Submittal  
Received  
2017-08-07

SHEET TITLE  
Window Light Box Details

**SHEET TITLE**  
Window Light Box Overview

**PROJECT NAME**  
BE WASHINGTON

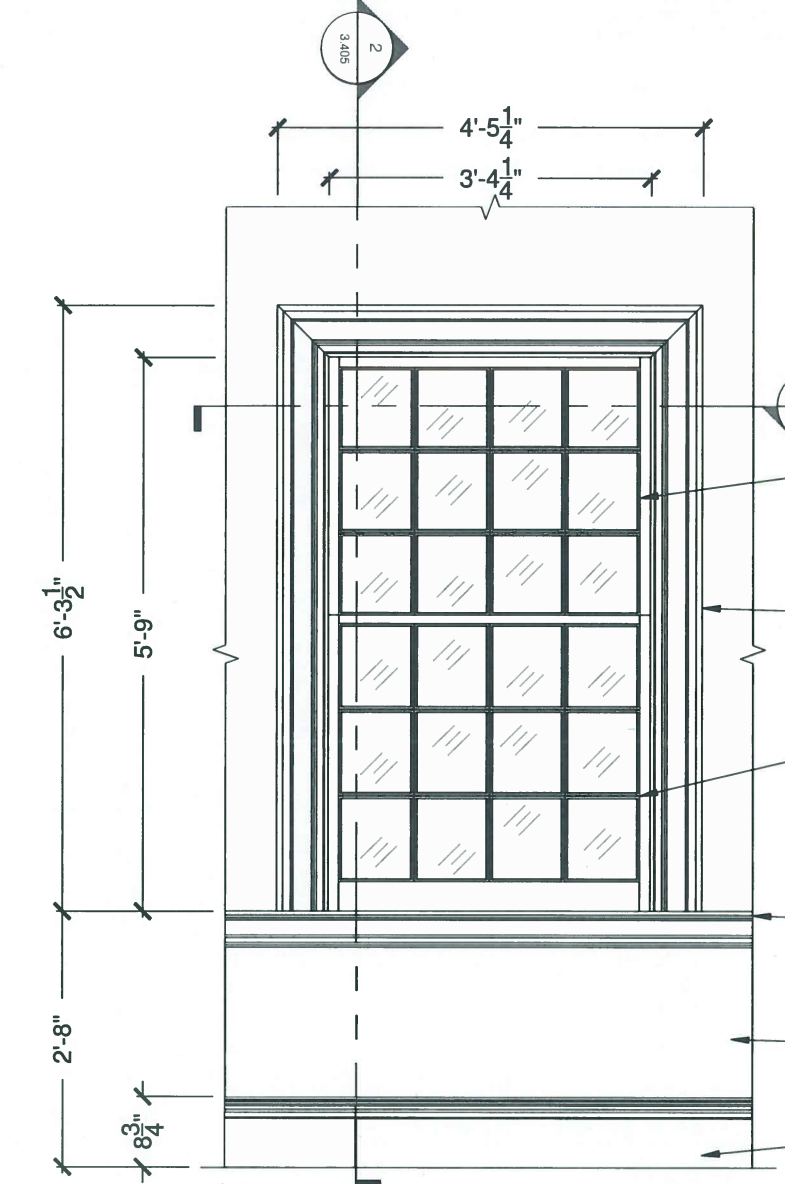
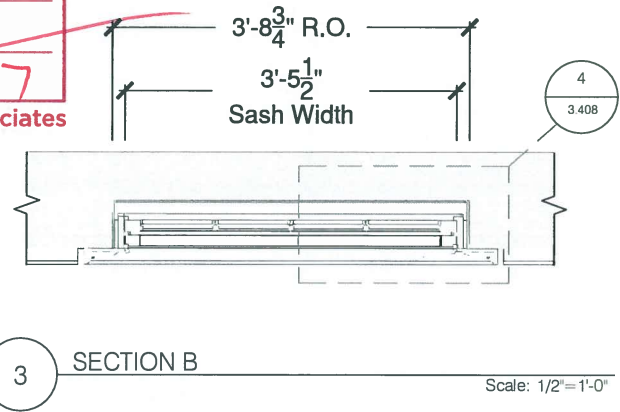
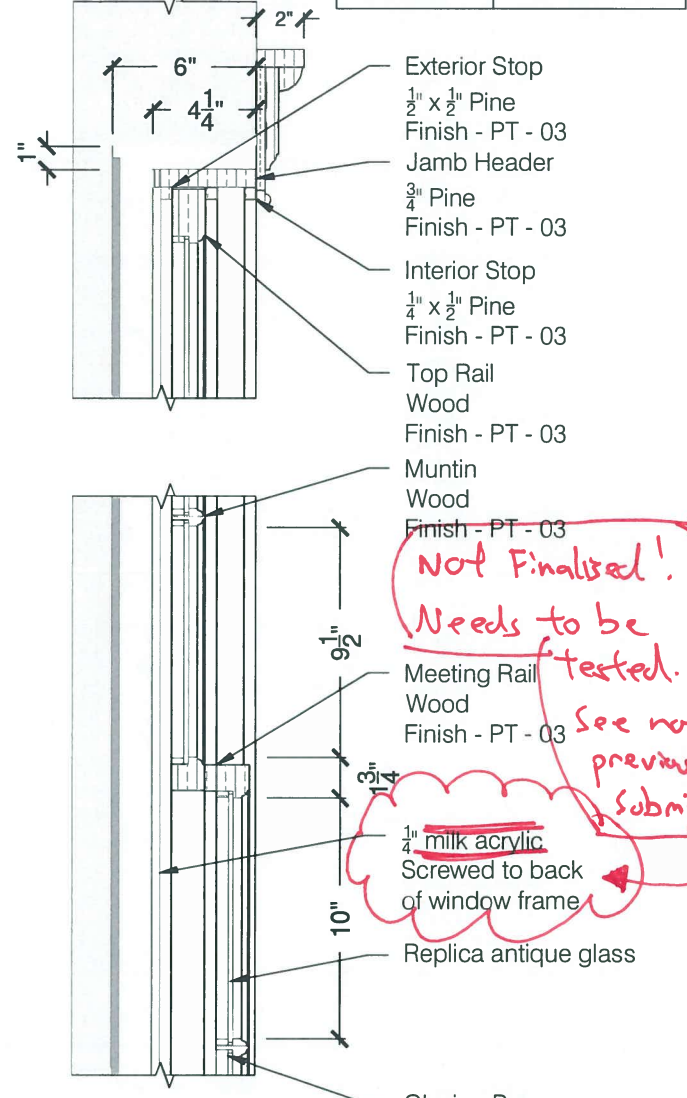
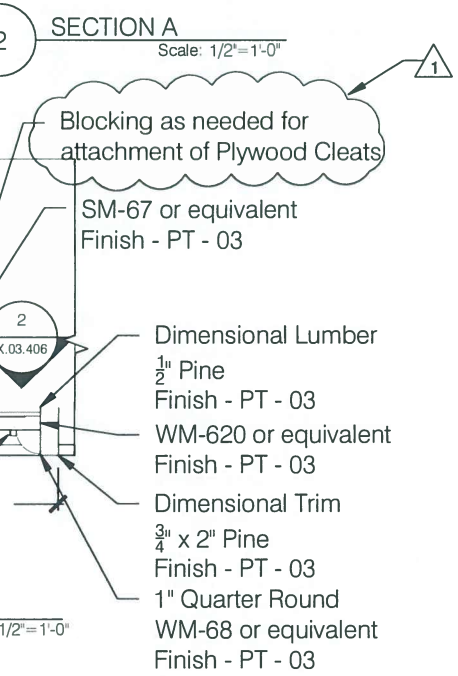
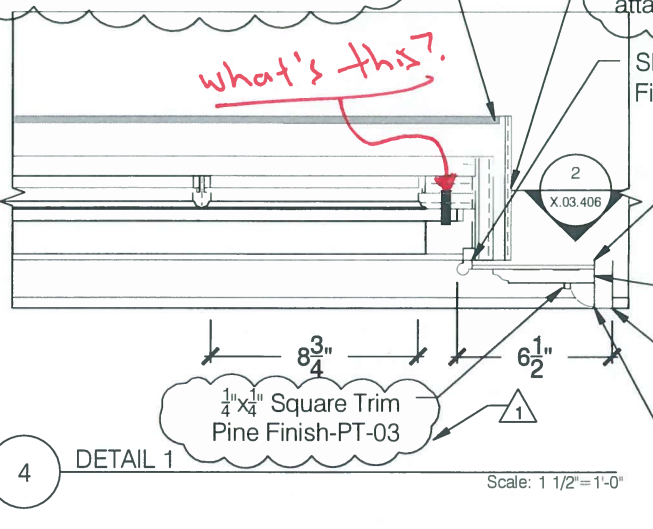
Need more info. where is chase to? Does this meet code this way? SG should do access hatch if hardware is in an adjacent recess by GC.

Not Finalised!  
Needs to be tested.  
See note previous submittal

what's this?

Window Assembly  
1/2" Plywood cleats  
Flat Head screw & Threaded insert  
2 SECTION  
X.03.405

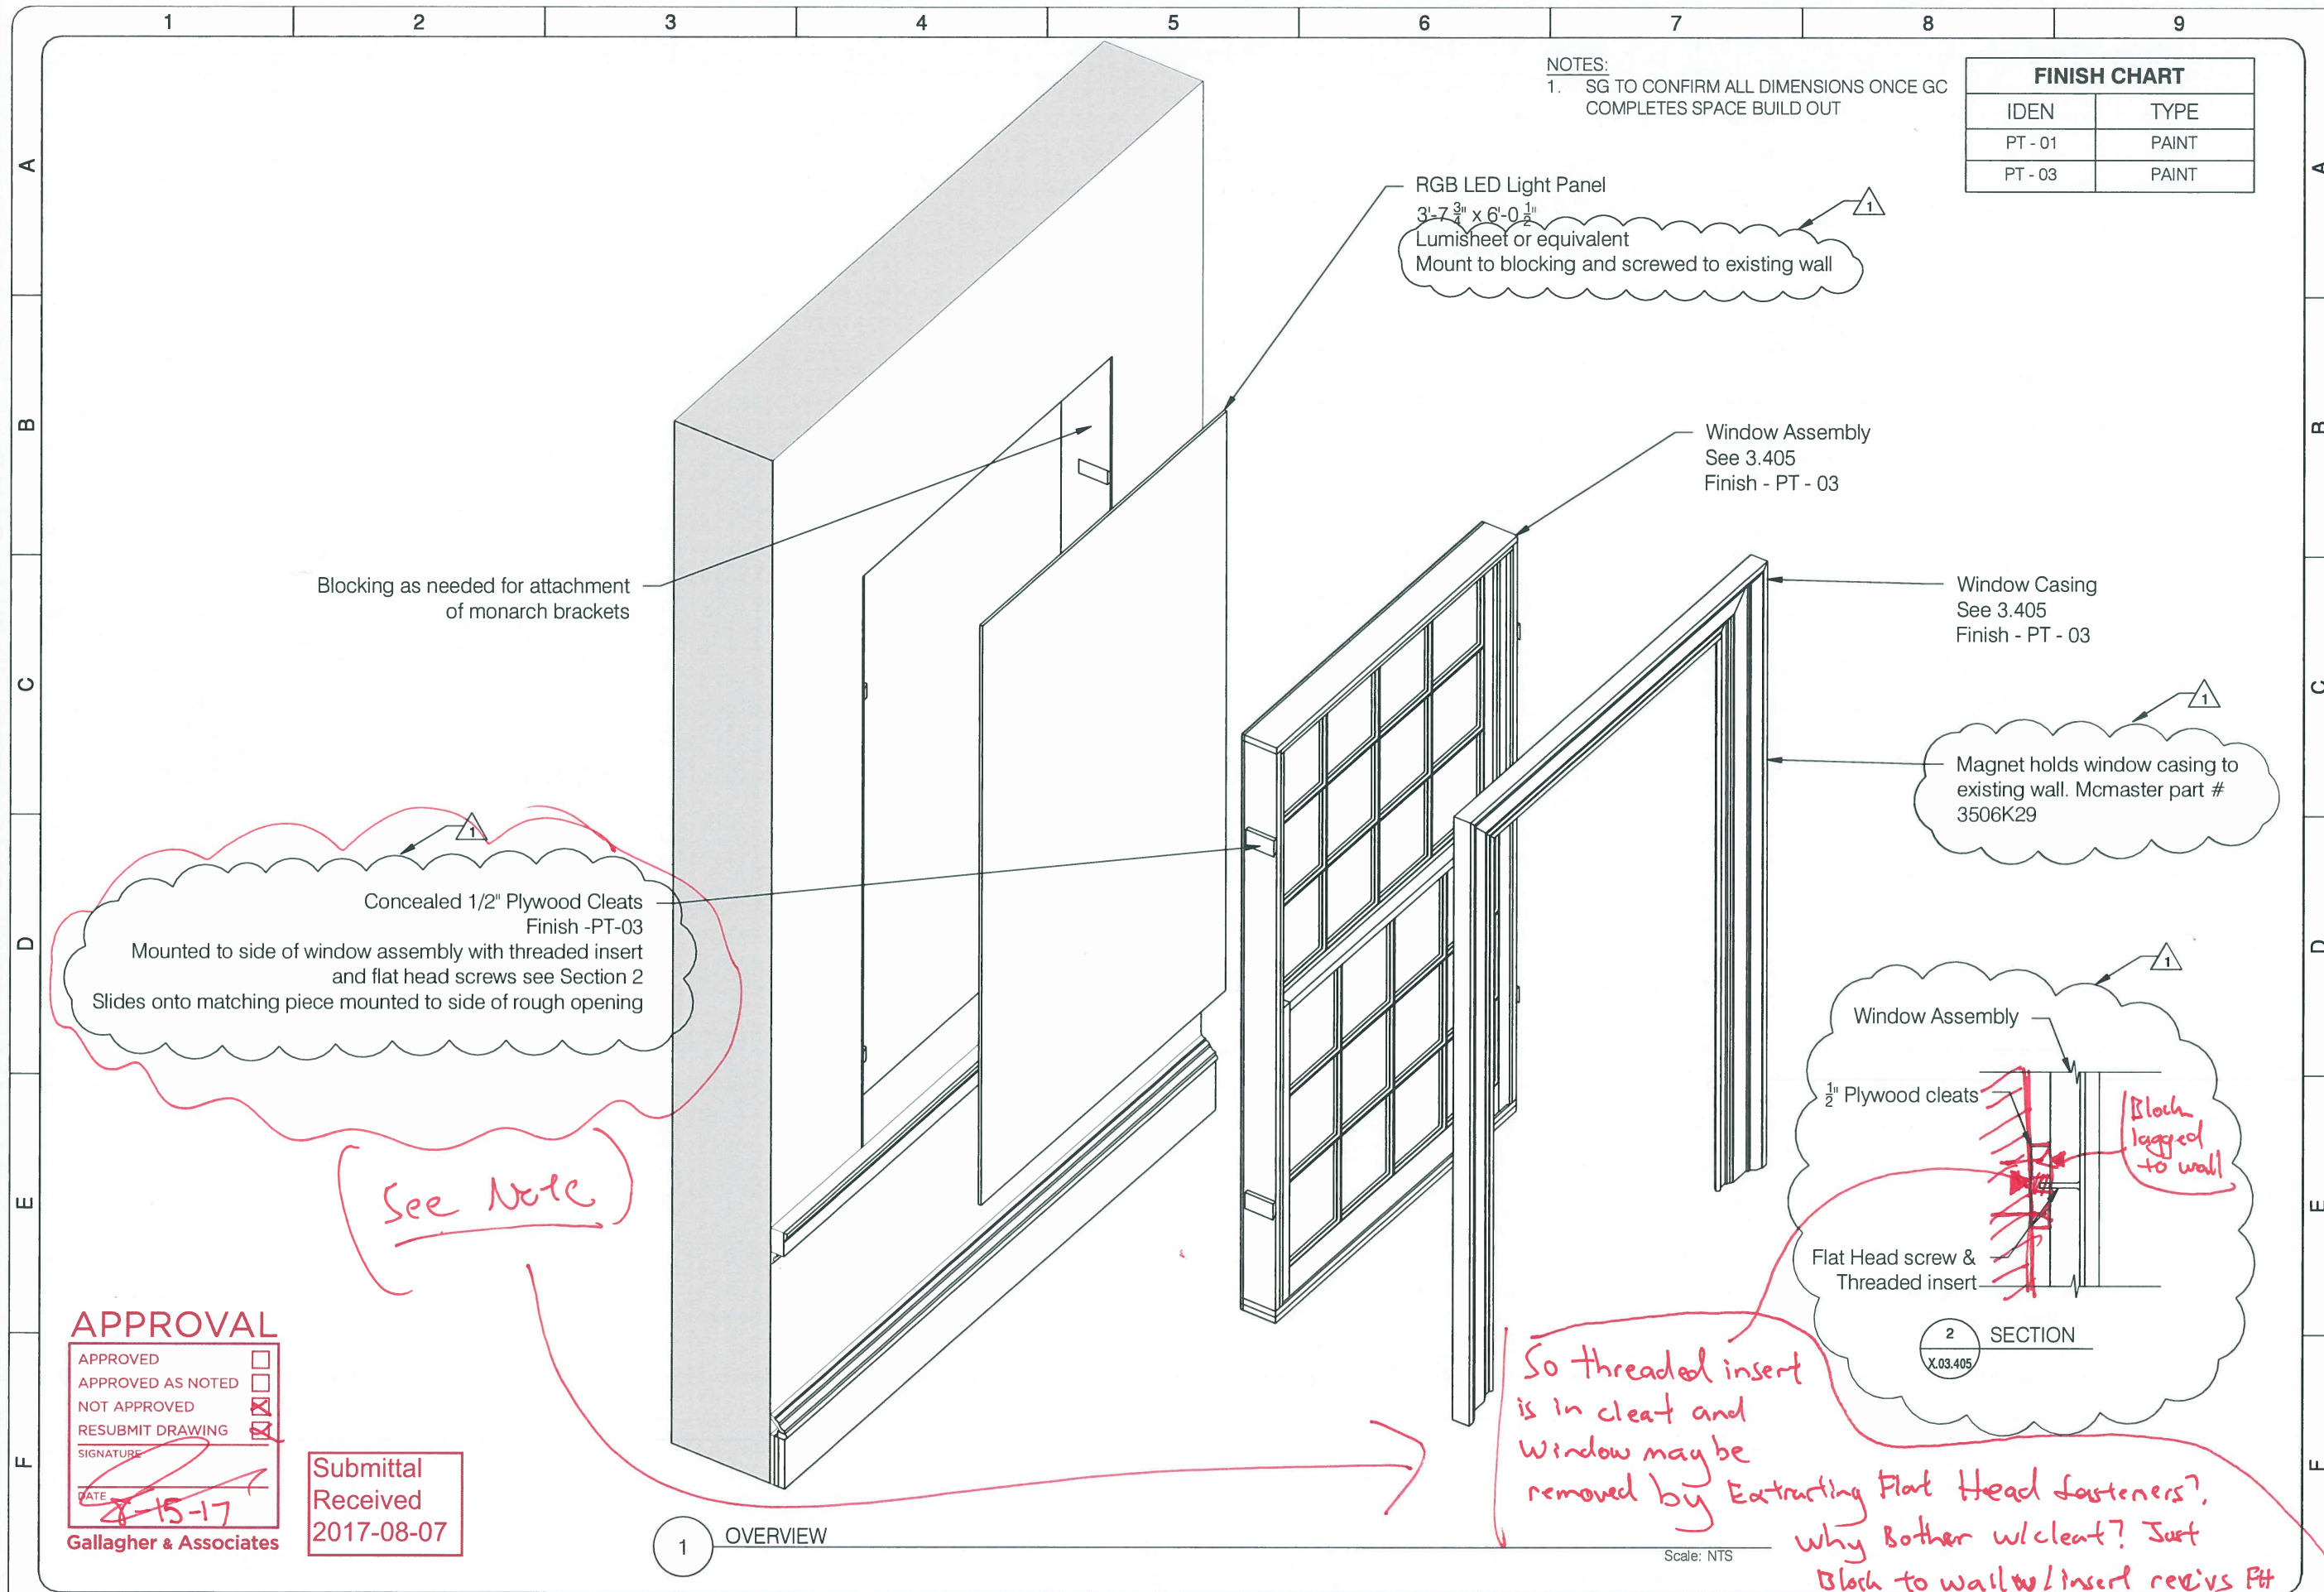
So threaded insert is in cleat and window may be removed by Extracting Flat Head fasteners? why bother w/cleat? Just Block to wall w/ insert reivs Ft fastener
